*Southern California Edison*  
**WODUP A.13-10-020**

**DATA REQUEST SET A.13-10-020 WODUP ED-SCE-03**

**Question PHS-09a:**

This figure is to replace the top figure on page 104 of the Field Management Plan.

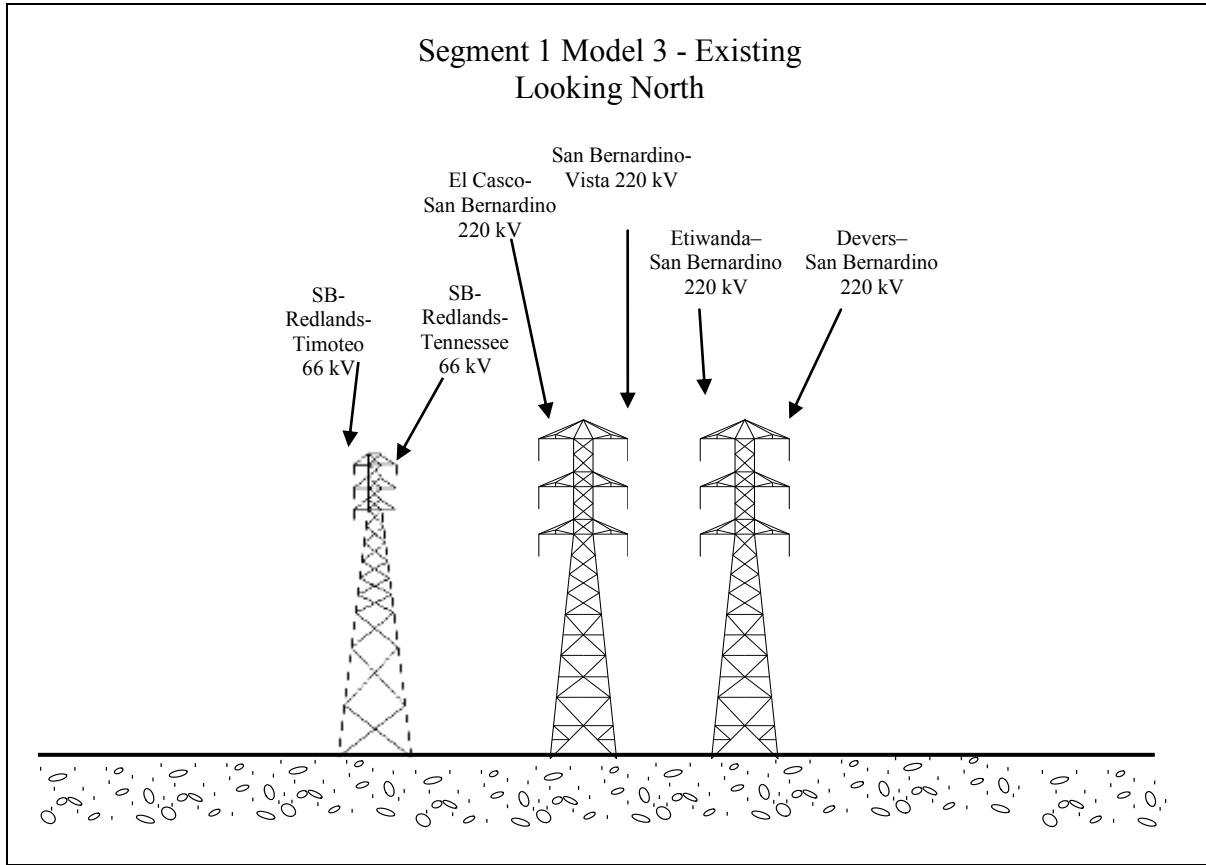
**PHS-9 Model 3 – Redlands Boulevard to Barton Road.** Note that in this Model it appears the FMP has shown that there are no 66 kV circuits on the ROW, either existing or proposed. Refer to Figures 7 & 8.

a. For this Model, Table 1 indicates, “Yes”, for utilizing taller structures where adjacent to populated areas. This section is adjacent to residential areas. Has SCE proposed taller structures for this entire section?

Figures 7 and 8 correctly depict the proposed configuration in the SCE ROW where there will be no 66 kV circuits for this section. However, the top figure on page 104, Segment 1 Model 3 Existing Configuration, is missing the existing 66 kV double-circuit on the west side of the ROW, and the 66 kV double-circuit on the east side should be removed. The attached figure should replace the top figure on page 104. The exact structure heights will be determined during final engineering. The EMF analysis was done based on the preliminary engineering design and the shortest proposed structure height of 110 feet. By increasing the structure height to 125 feet or by elevating the conductor minimum ground clearance by 8 feet from SCE’s design standard for minimum ground clearance near those short structures would achieve a 15% EMF reduction at edges of the ROW.
